CITY OF PORTLAND, OREGON – BUREAU OF DEVELOPMENT SERVICES

SUBJECT: **Site Evaluation Report—First Revision**  
Land Feasibility Study # 10-08 aka 08-125829-SE  
For Property: 9555 NW LIGHTNING RIDGE DR, 1N1W23 TL600, R201097

SUBJECT: **Site Evaluation Report**  
Land Feasibility Study #10-08 aka 08-125829-SE  
For Property: 9555 NW LIGHTNING RIDGE DR; 1N1W23 00600; R201097

LFS # 10-08 revised

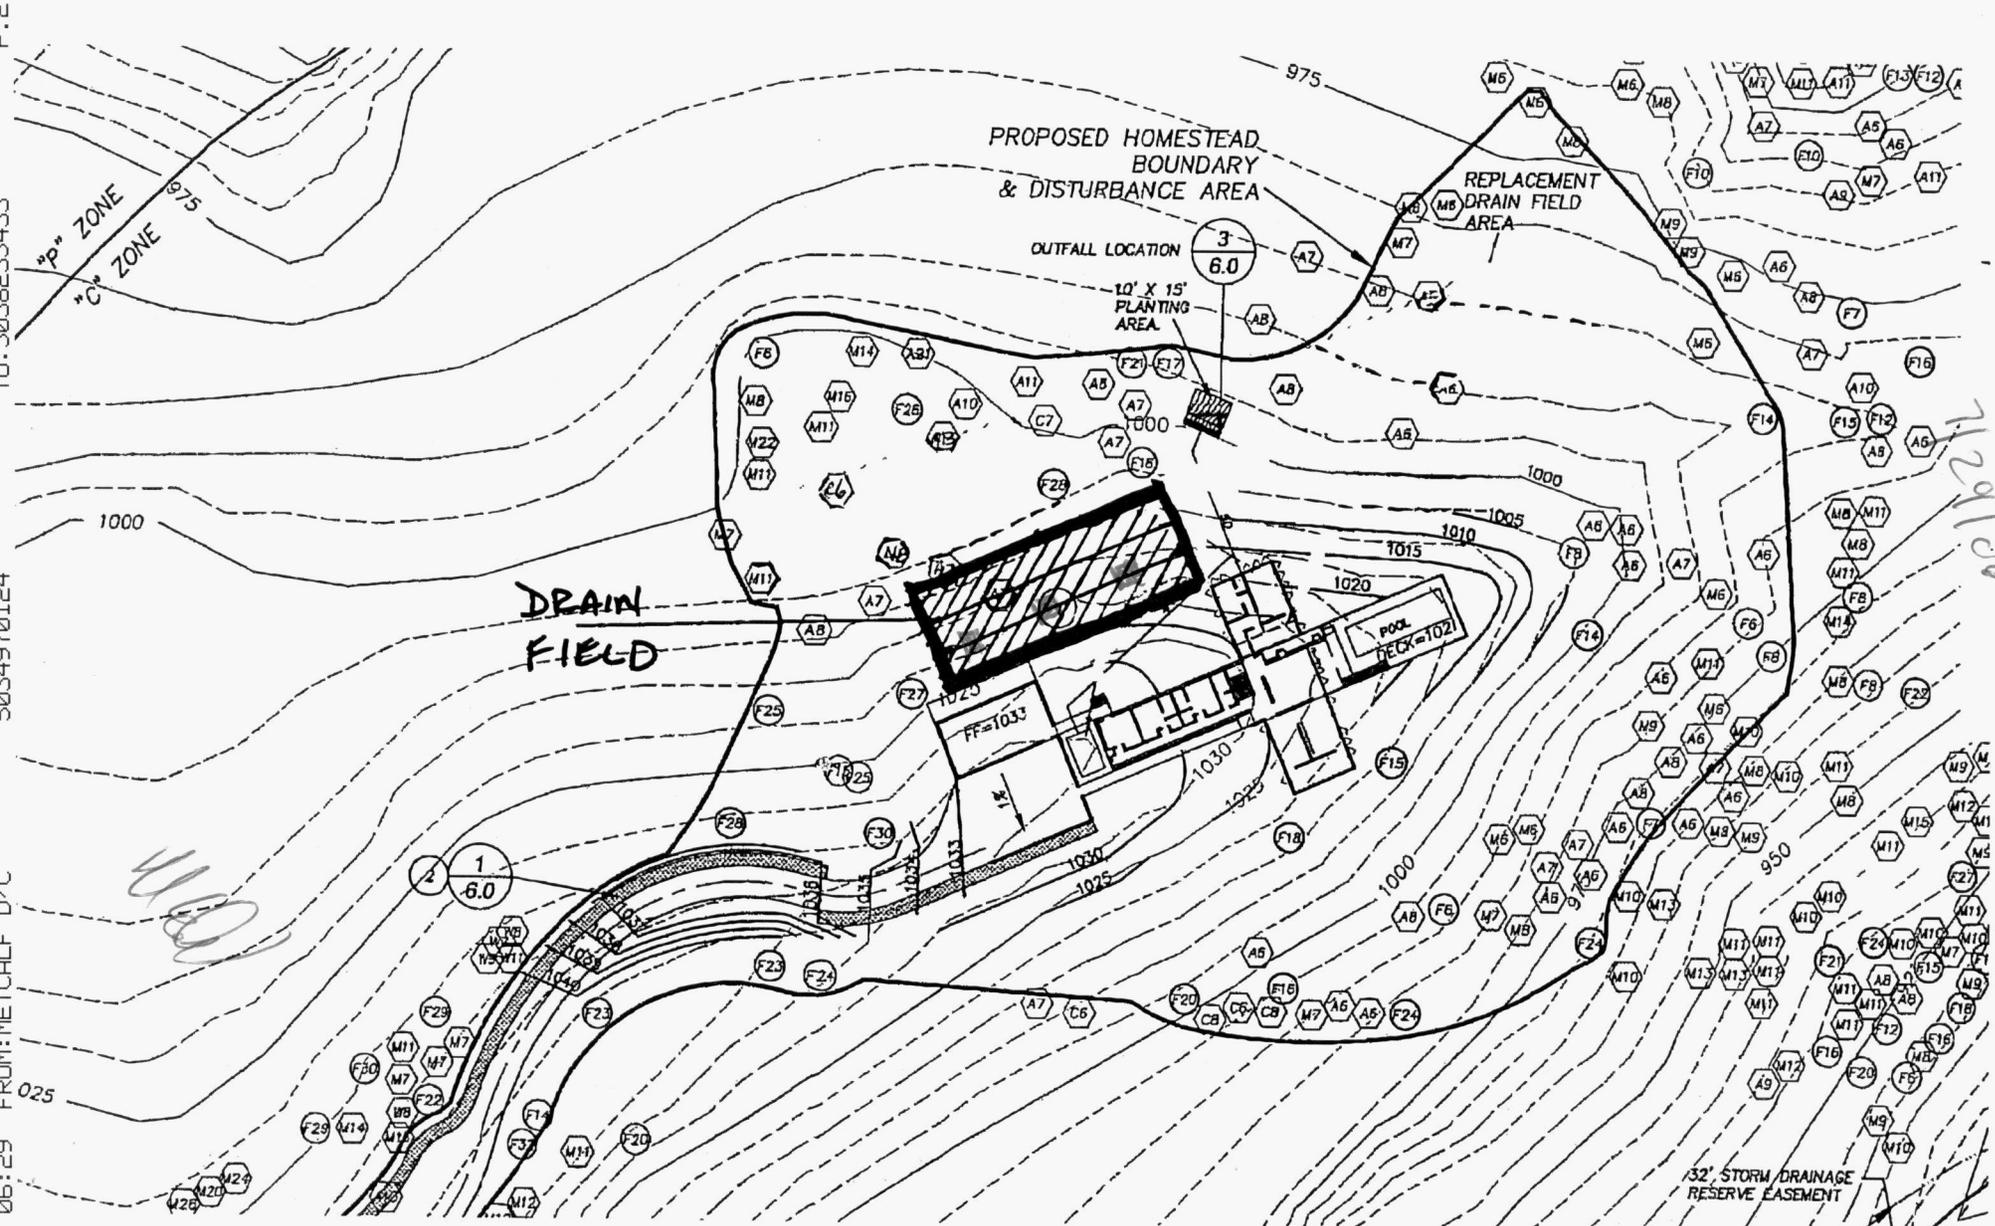
1. Serial distribution system with drop box.
2. One, 1000 gallon septic tank.
3. 440 lineal feet of absorption trench shall service a maximum of four (4) bedrooms.
4. Trench depth should be a minimum of 24 inches and a maximum of 30 inches.
5. The drainfield shall be placed in the area of the four test pits at the bottom of the toe slope.

DRAIN FIELD LOCATION  
 all 3 approved for standard

CRAIG ZANON  
 LOT 7 LAKOTA SUBDIVISION  
 SITE DEVELOPMENT PLAN  
 REVISED ALTERNATIVE 2

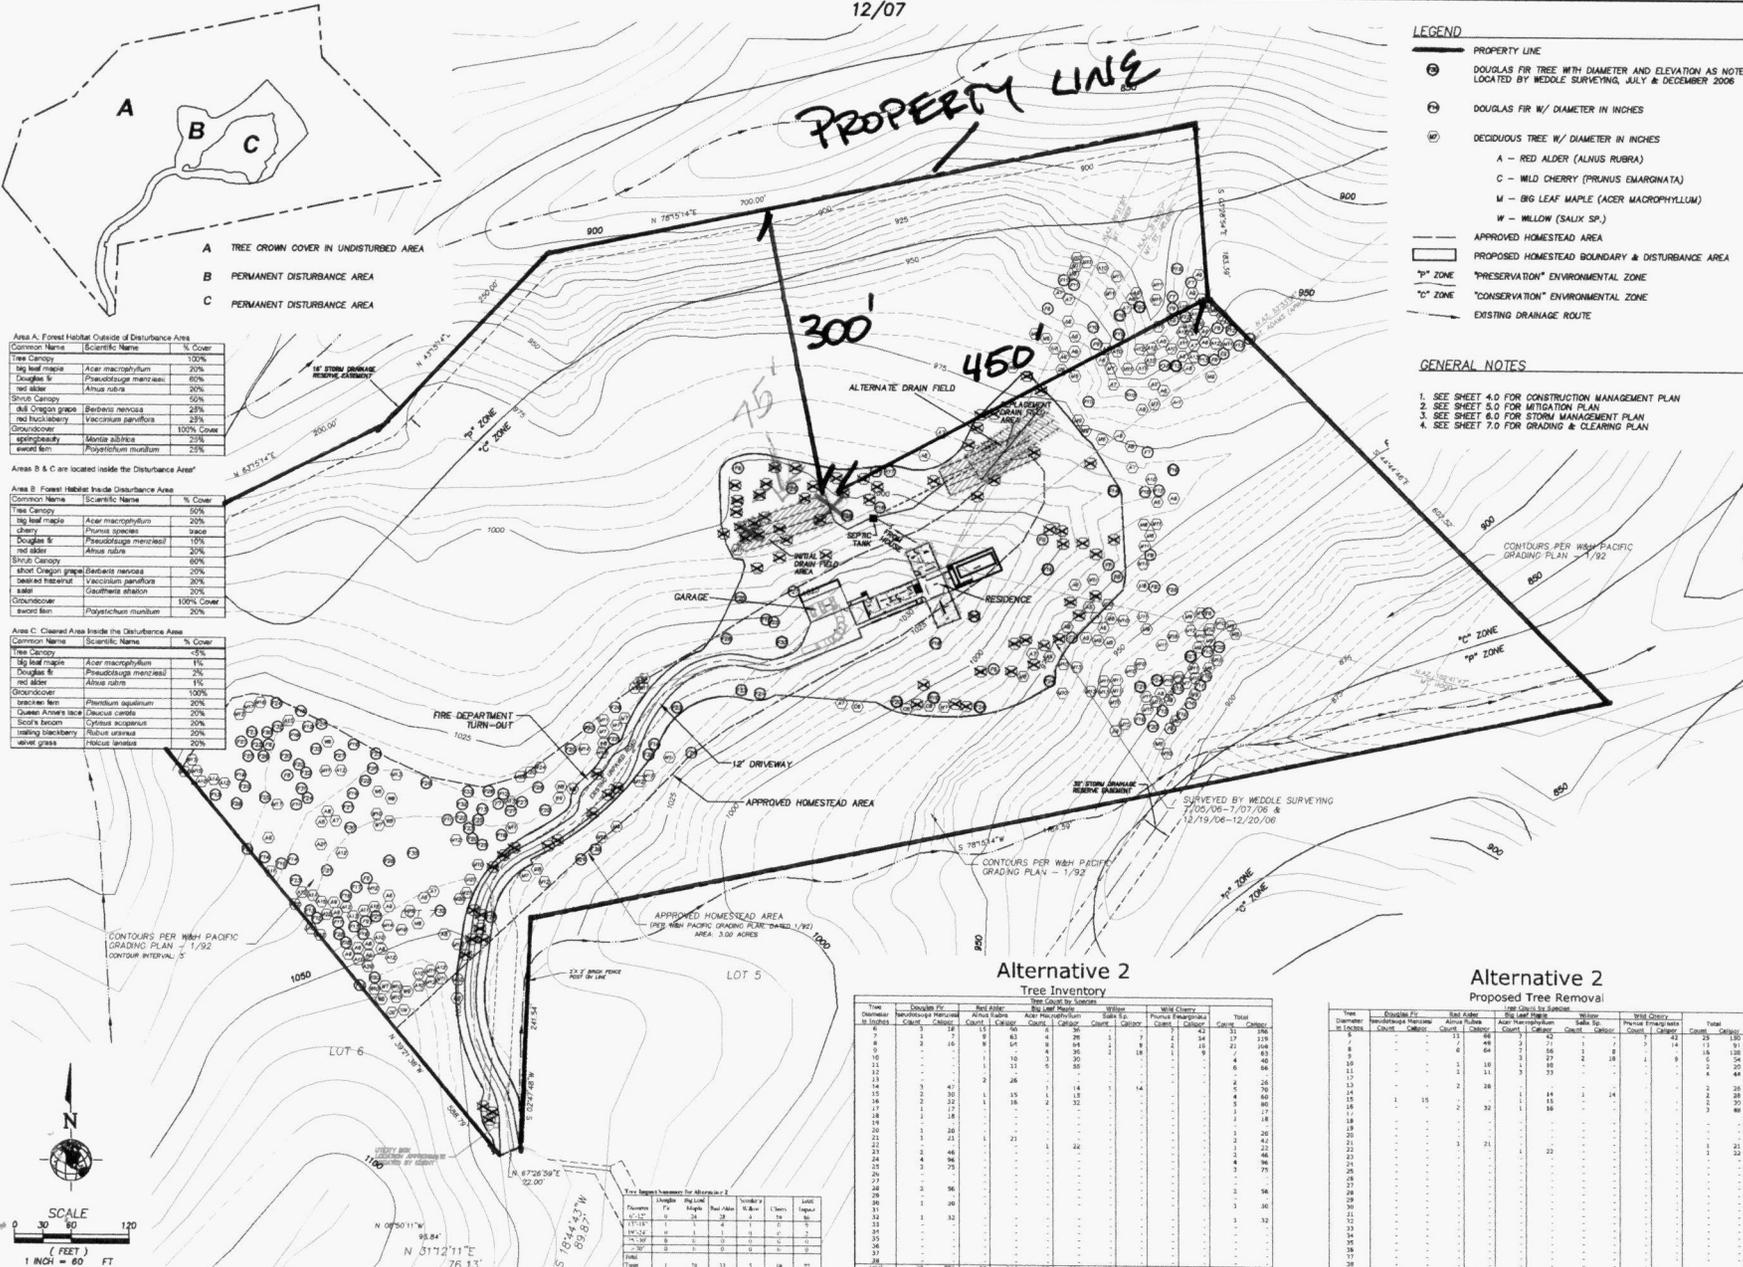
1. One 1500 gallon dosing septic tank discharging to a 420 square foot sand filter.
2. Sand filter drains to a second tank (1000 gallon), which goes into an equal distribution system with hydrosplitter.
3. 66 lineal feet long absorption trench per bedroom for first three bedrooms and 33 lineal feet per bedroom for any bedrooms over three. Note: The system needs to be sized for a minimum of three bedrooms.
4. Trench depth should be 18 inches minimum/maximum.
5. Both primary and secondary drainfields shall be placed around the three test pits.
